6675A-11

S E R V I C E N O T E

**6675A - DC POWER SUPPLY, 0-120 V, 0-18 A, 2160 W.
GPIB CONTROLLED**

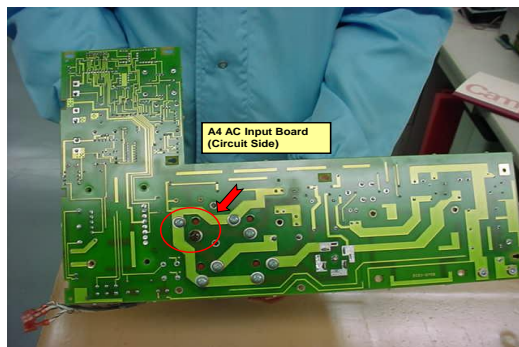
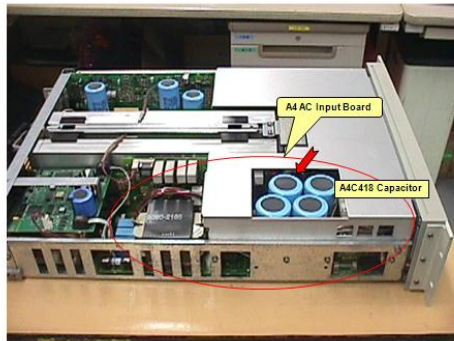
The four filter capacitors circuit reference (C416-C419) on the A4 AC input board starts leaking electrolyte - not through the pressure valve in the bottom as one would expect but through one of the terminal screw bushings.”

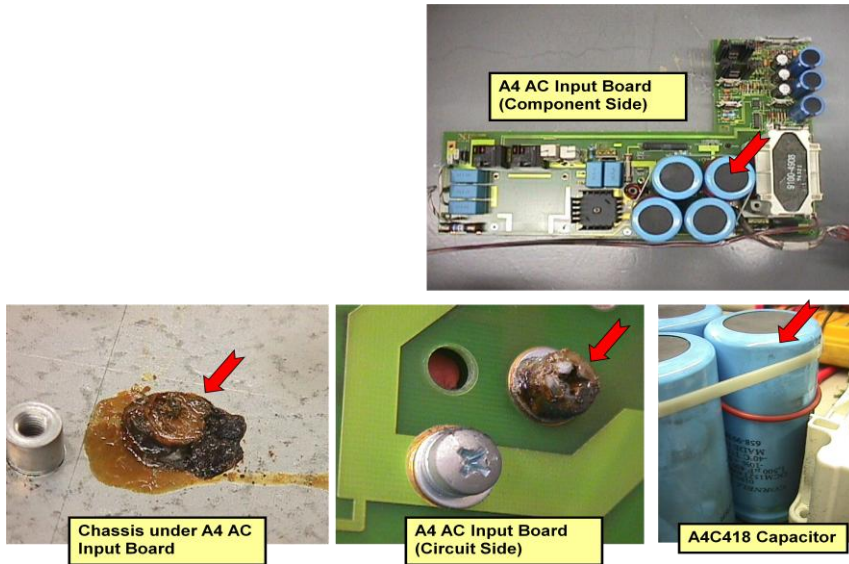
The screw P/N 2680-0217 length currently being used was not considered and the length was overlooked. The screw length is 0.375 inches long. We have found that the screw can be 0.055 inches too long and may bottom out causing the tapped hole in the header of the capacitor to become cracked or become broken.

When this happens the electrolyte will slowly leak out over time, and cause the defect described. This situation is even worse due to the capacitor is mounted with the header face down. If the capacitor was mounted header face up a cracked or broken header would not have caused this problem, the electrolyte could not leak out.

1. All affected models and tested assemblies WIP (Work In Process), FGI (Finished Goods Inventory) at SPO (Support Parts Organization) & AMC (Asian Manufacturing Center) has been inspected for capacitors with damaged headers due to the incorrect screw
2. When this repair is being done all of the hardware described above should be replaced (It is NOT recommended that any of the hardware be reused)
3. The following figures can be used when doing the repair.
4. Inspect the assembly as described below.
5. The last figure will aid in the reassembly of the hardware and the capacitors.
